REFERENCE:	Nova Bus Manuals
SECTION:	14: Auxiliary heater
RS N°:	PIP100

SUBJECT:	Auxiliary heater
JUSTIFICATION:	Auxiliary heater Thermo 350 is discontinued. The Thermo Plus unit will replace the current unit only if the whole unit needs to be replaced. There is no need to retrofit any buses with the new Thermo Plus units. Replacement parts are available for the current Thermo/Thermo-S units already installed. Please refer to the spare part list for those heaters. If required, contact your local customer support manager for more information.

Figure 2 - Drill the Two Holes in the Cradle (Bottom View)

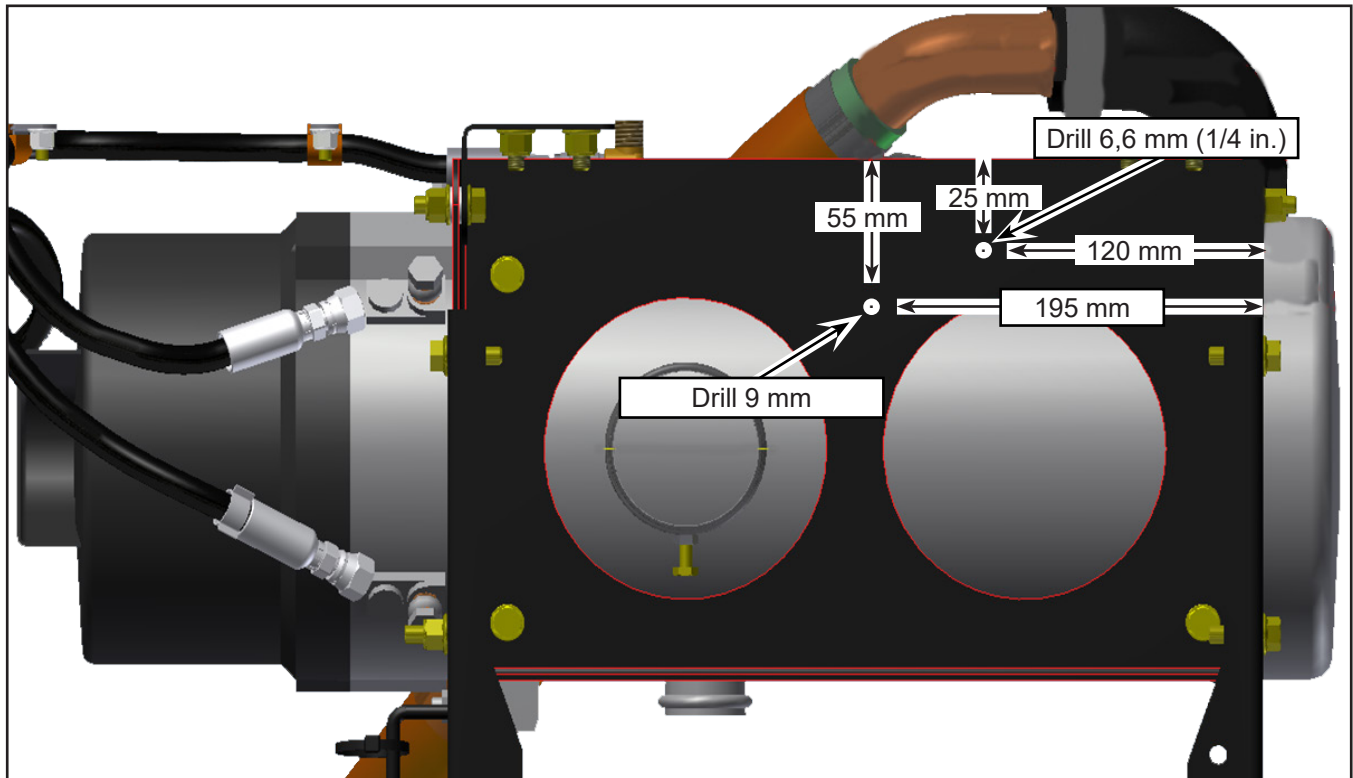
The new Thermo Plus unit requires the new harness from the material list to be connected to the existing NovaBus harness. Two holes will be required in the cradle.

- 1.5. Carefully drill the two holes as per the Figure below. The 6,6 mm hole will be used to bolt on the relay, the 9 mm hole for a fir tree mount N57807. It is recommended to apply paint or a corrosion protector on the bare metal.

Figure 4 - Route and Secure the Harness (View With the Cradle Pivoted Downward)

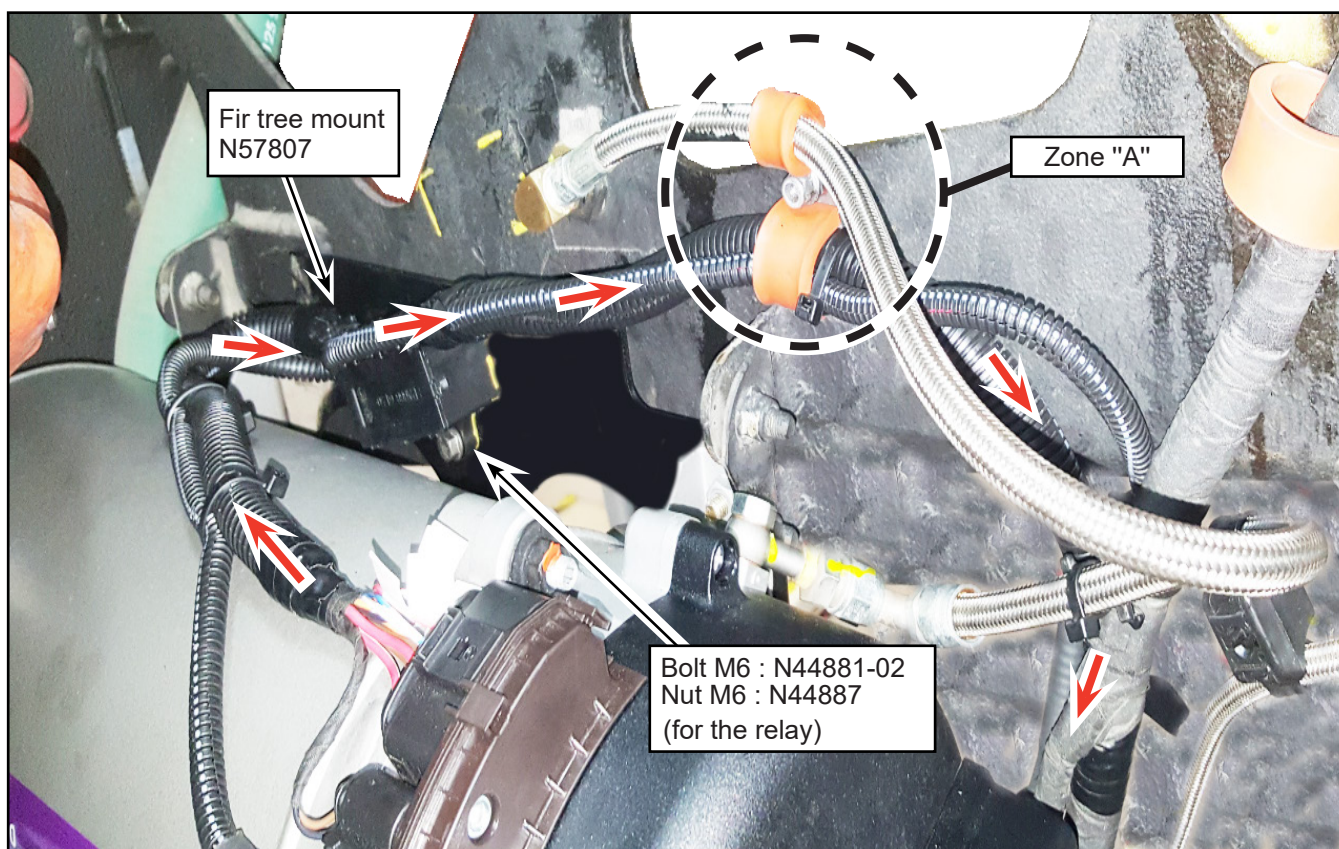
- 1.8. Route the new harness from the auxiliary heater unit head to the existing engine harness. Secure the harness relay on the engine cradle using the holes drilled in the previous step.
- 1.9. Your bus configuration may differ for the zone "A". Use a dual clamp tie N37749 to secure the harness to the fuel line to avoid interference with the cradle pivot.

Figure 5 - Route and Secure the Harness (View With the Cradle Bolted in Place)

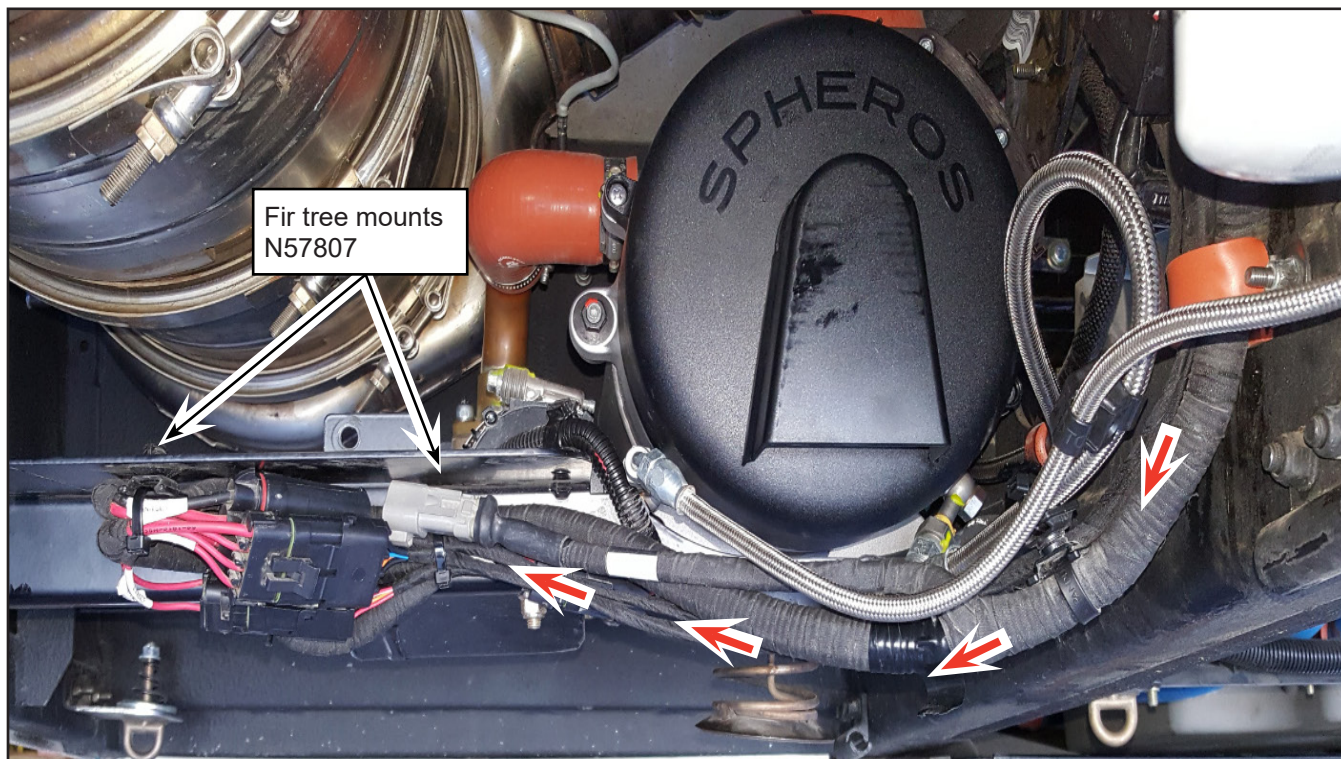
- 1.10. Finish securing the harness with fir tree mounts N57807.
